Results: Three apparent violations of NRC regulations were identified. The First Violation (identified in paragraph 2) involved noncompliance with Unit 1 Technical Specification 3.3.1.(c). Since initial startup of Unit 1 in 1974, the unit was operated with two of the three service water pumps not fully operable. The controls for Pumps P4A and P4C contained an unidentified set of contacts (that were supposed to have been removed during startup testing) which could have prevented the pumps from restarting during certain accident conditions. As such, this issue was considered by the NRC as safety significant. The second violation (identified in paragraph 3) involved the failure to maintain fiberglass sleeving for separation in accordance with the installation drawings.

2. Service Water Pump Control Circuit Deficiencies

Service Water Pump Configuration and Pump Breaker Anti-Pump Circuit Operation

SERVICE WATER PUMP P4A BREAKER A302 CONTROL CIRCUIT
(SIMPLIFIED BLOCK DIAGRAM)

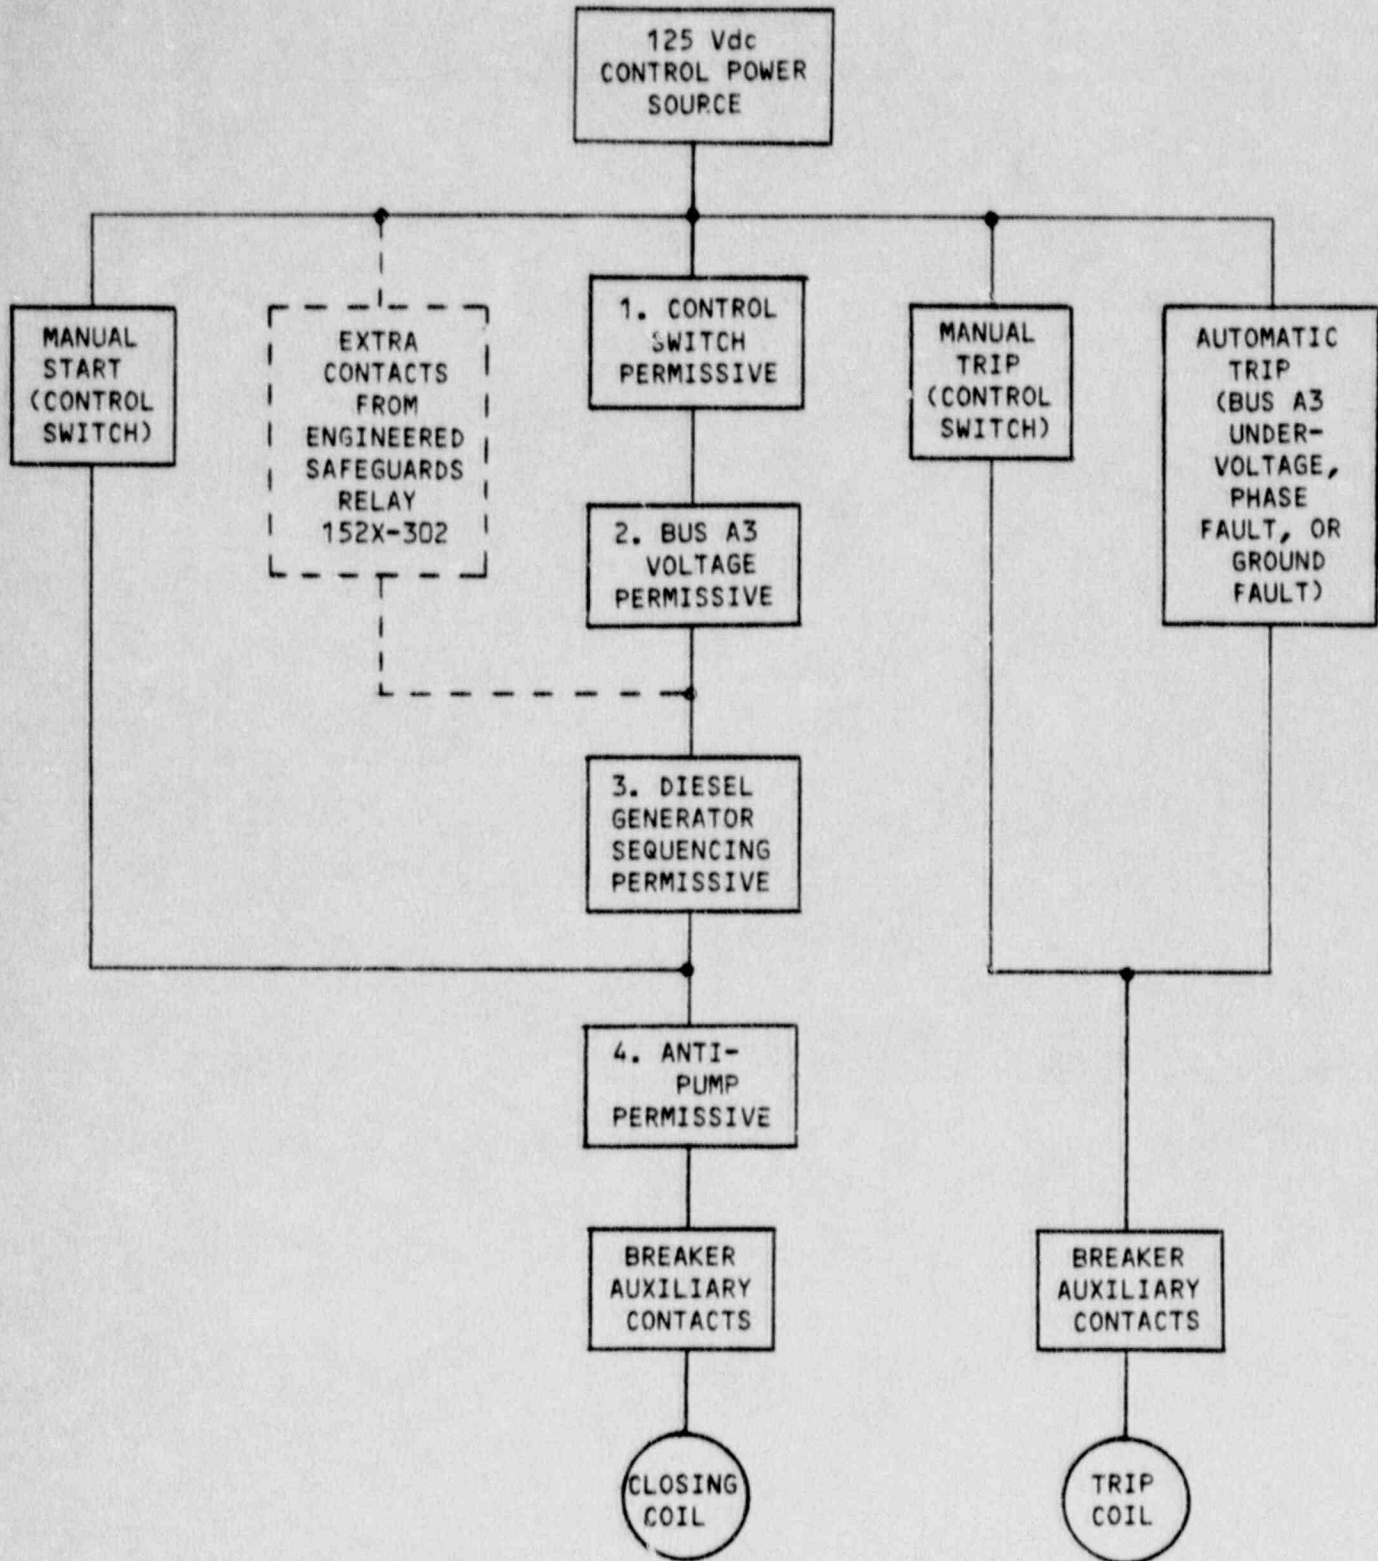
None of the above conditions for automatic restart of a service water pump depend on the existence of an ESF signal. However, the extra contacts from engineered safeguards Relay 152X-302 that were found wired onto the breaker close circuit effectively bypass the control switch and Bus A3 voltage permissives. The extra contacts are shown using a dashed line in Figure 2. The problem caused by the extra contacts is that on an ESF signal where a slow transfer from the unit auxiliary transformer to the startup transformer occurs, the breaker will trip on bus undervoltage, but the existing breaker close signal will not clear because the Bus A3 voltage permissive is bypassed by the contact. The slow transfer will restore power to Bus A3 within 2 seconds (therefore, Bus Feeder Breaker A309 remains closed), but not before the breaker has attempted to reclose and the anti-pump circuit has energized and sealed in. Since both the remote and local control switch contacts are bypassed by the extra contact, reset of the anti-pump circuit (hence, breaker closure to restart the pump) is not possible without nonroutine operator action (e.g., removing the circuit breaker 125 VDC control power fuses at the breaker cubicle in the switchgear room. If the extra contact were not in the circuit and a slow transfer occurred, the Bus A3 voltage permissive would clear the close signal at the same time that the breaker trips on bus undervoltage. Reclosure of the breaker does not occur until bus voltage returns to an acceptable level (seal in of the anti-pump circuit will not occur until after the breaker has successfully reclosed).
